Work Order ID 71362

Item Name: Crosstube Fwd

DRAWING NO. D206-667-143	TITLE CROSSTUBE ASS'Y (206L HIGH FWD)	REV. C	DART AEROSPACE LTD ENGINEERING ORDER		D.E.O. NO. D206-667-143-C-1	SHEET NO. SHEET 1 OF 1	SCALE NTS
DRAWN 97	CHECKED ASS	MFG. APPR. [Signature]	APPROVED [Signature]		DE APPR. [Signature]		
DATE 11.07.15	DATE 11.07.20	DATE 11.07.21	DATE 11/07/21		DATE 11.07.21

REPLACE MAGNOBOND WITH PROSEAL

D206-667-143
ASSEMBLY DETAIL
(VIEW LOOKING FWD)

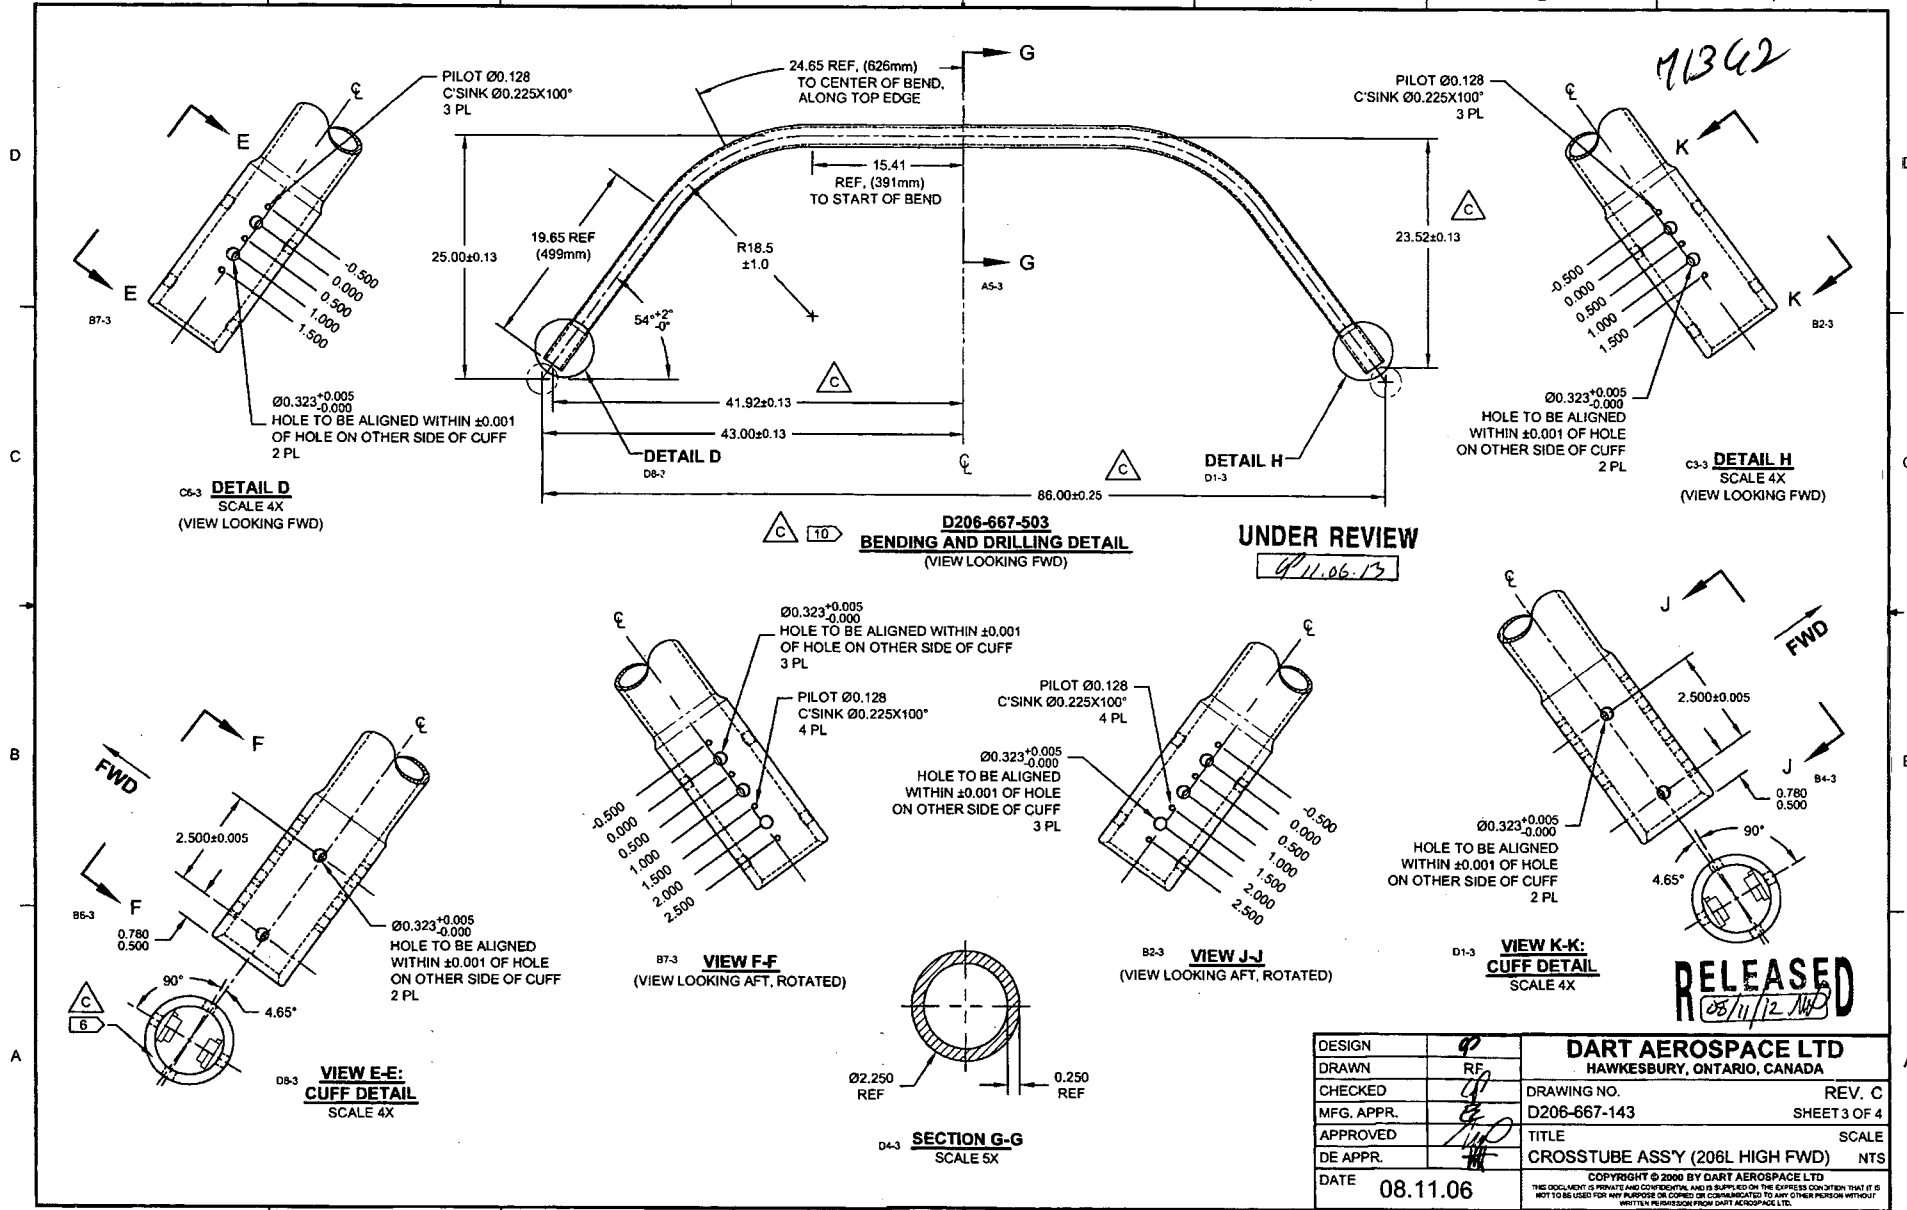
W/O: 71362 WORK ORDER CHANGES							
DATE	STEP	PROCEDURE CHANGE	By	Date	Qty	Approval Chief Eng / Prod Mgr	Approval QC Inspector
11.06.29	230	BOND SUPPORTS USING PROSEAL PER ATTACHED PROCEDURE (EMAIL)	RT	11-07-27		P 11.06.29 051042	W03/02

- Scuff paint under support, clean with MEK
- Completely remove any finish on support (if present), scuff bottom surface of support, clean with MEK
- Apply a 0.04" – 0.07" layer of Proseal 890 class B-2 on bottom of support and install wet.
- Install clamps and torque per dwg
- Clean up excess proseal
- Let cure for 72 hours after installation, recheck torque.

- Remove finish on xtube in area of support down to alodine finish.
- Touch up alodine on xtube in affected area
- Completely remove any finish on support, scuff bottom surface of support
- Apply a 0.04" – 0.07" layer of Proseal 890 class B-2 on bottom of support and install wet.
- Install clamps and torque per dwg

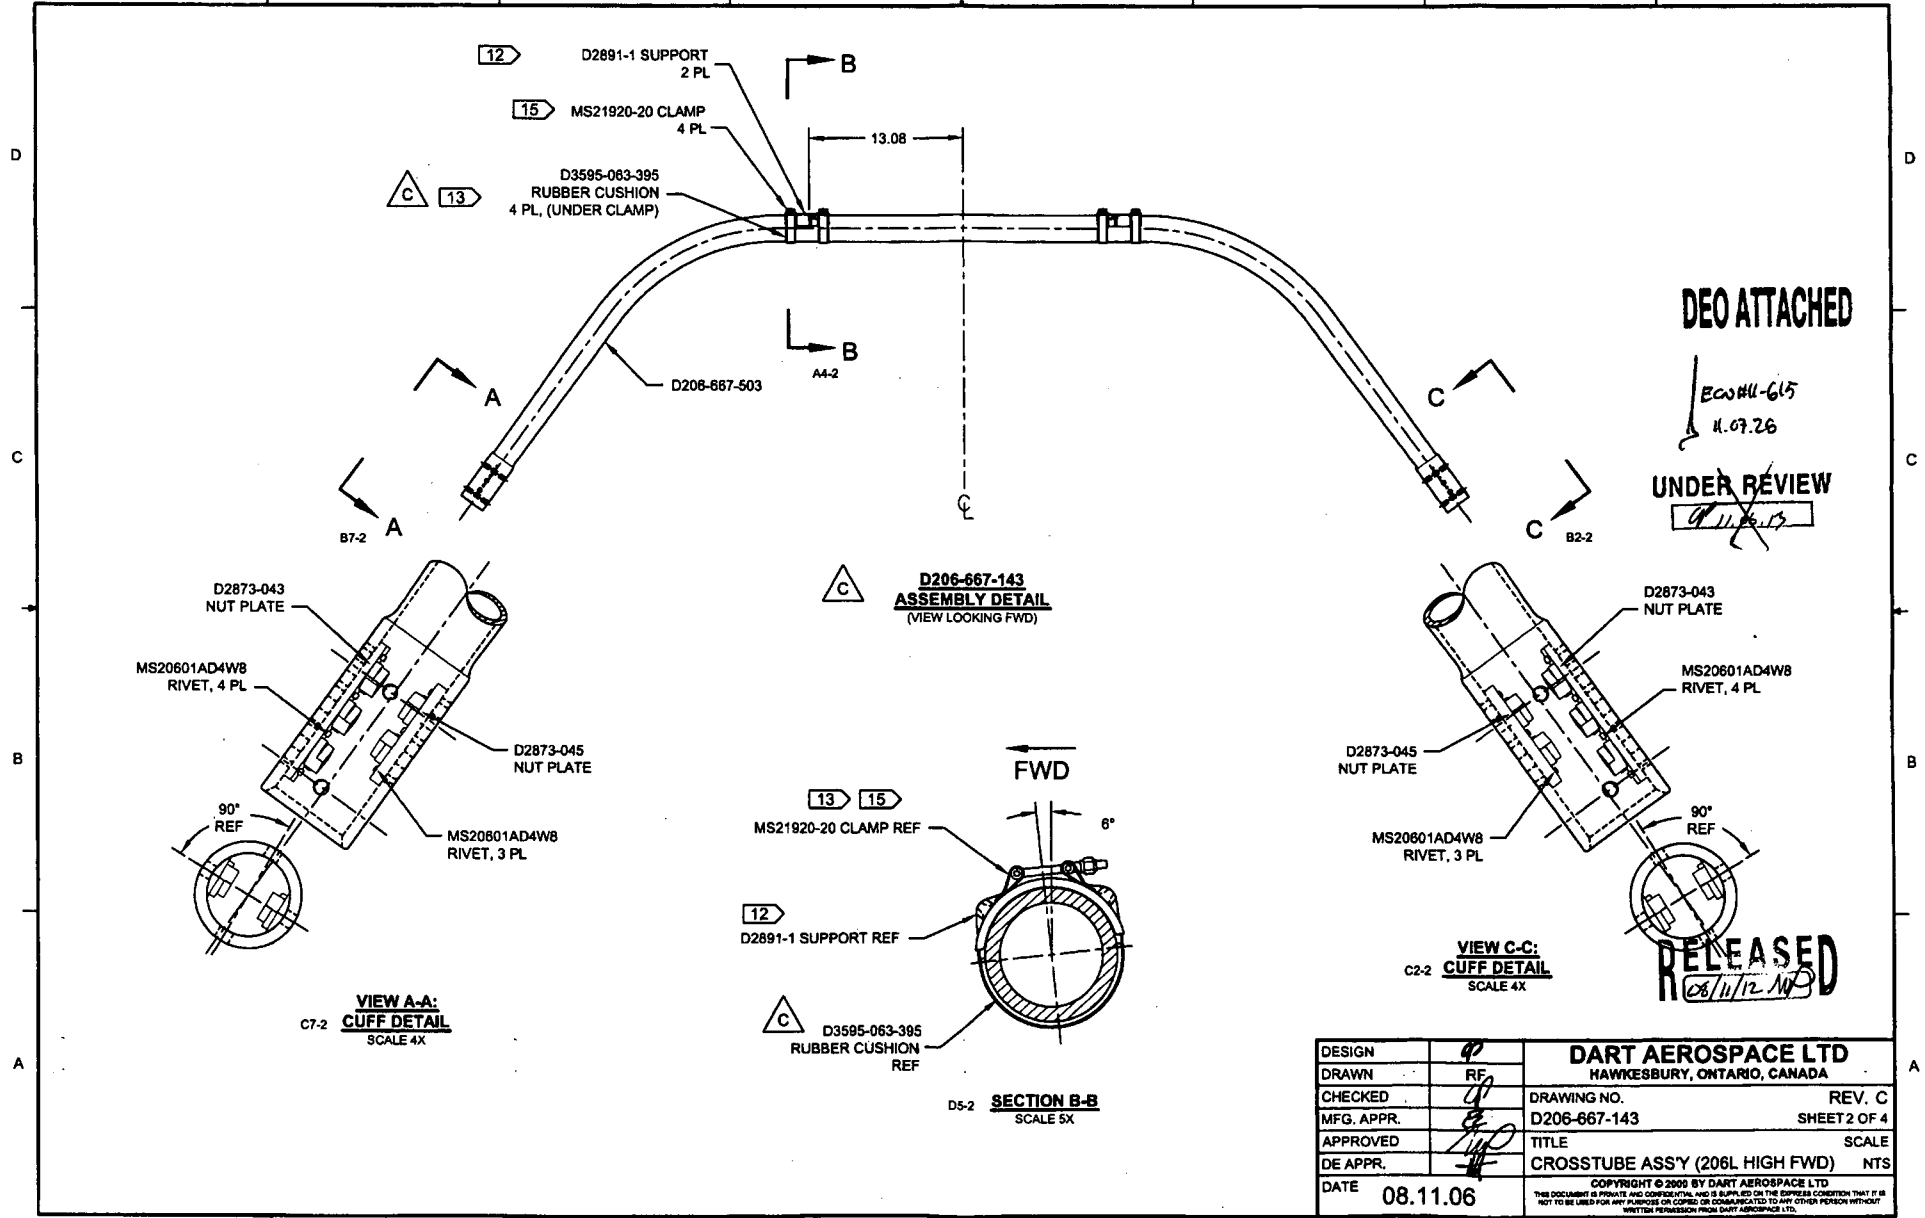
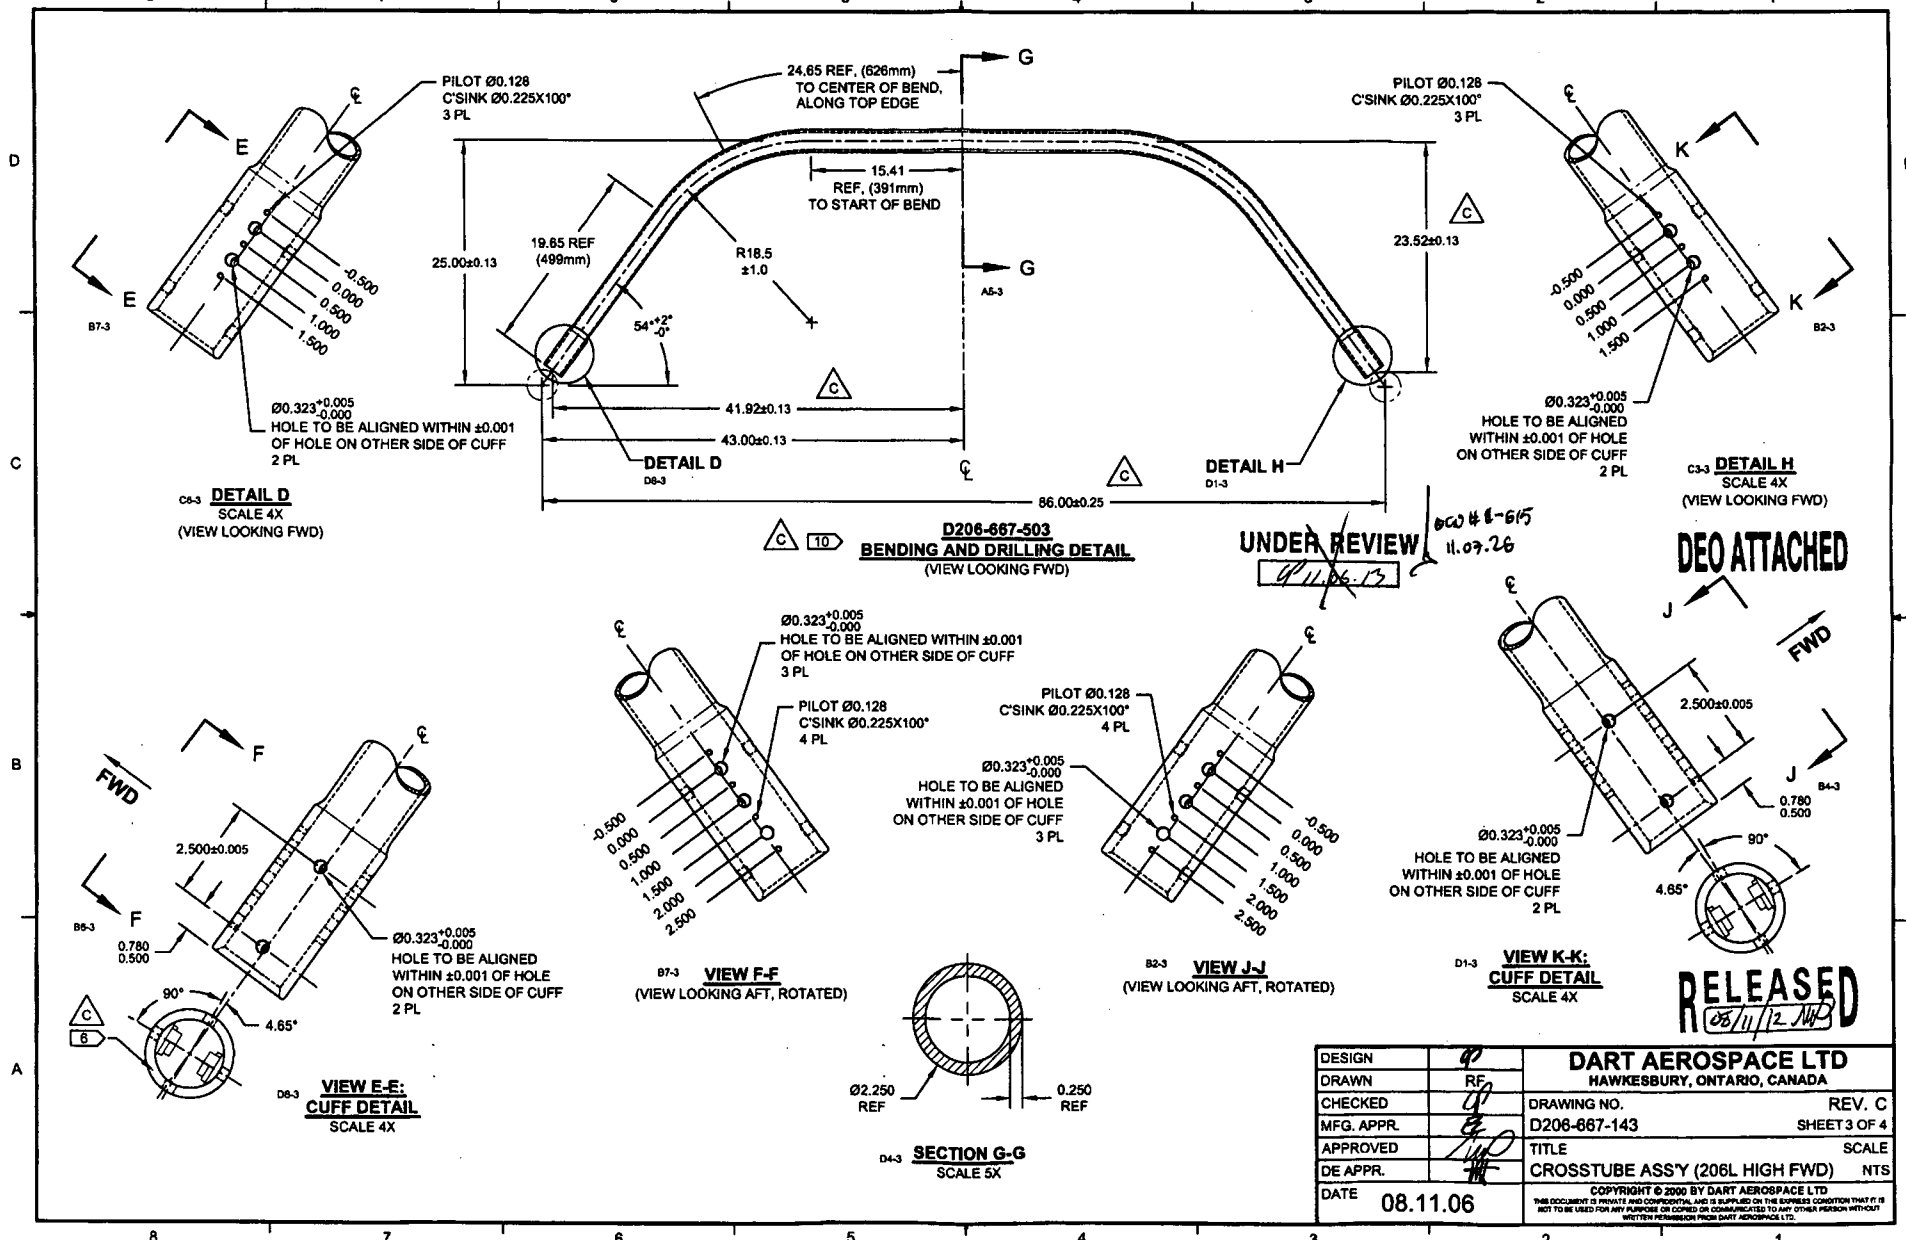
NOTE 12 & 15, SHEET 1 IS AMENDED AS FOLLOWS:

- 12) TO INSTALL D2891-1 SUPPORT: ABRASE MATING SURFACE OF SUPPORT AND CROSSTUBE WITH 180-GRIT SANDPAPER AND REMOVE RESIDUE WITH MEK (OR EQUIVALENT). APPLY A 0.04" TO 0.07" THICK LAYER OF PROSEAL 890 CLASS B-2 (OR AMS-S-8802 CLASS B-2) SEALANT TO MATING SURFACE OF SUPPORT.
- 15) TORQUE CLAMPS 80 TO 100 IN-LB. ENSURE AT LEAST 1.5 THREADS SHOWING IN SAFETY AND THAT NUT HAS NOT BOTTOMED-OUT AFTER TORQUING. **PRIOR TO PACKAGING, RE-CHECK TORQUE ON CLAMPS AFTER PROSEAL 890 SEALANT HAS CURED FOR 72 HOURS.**
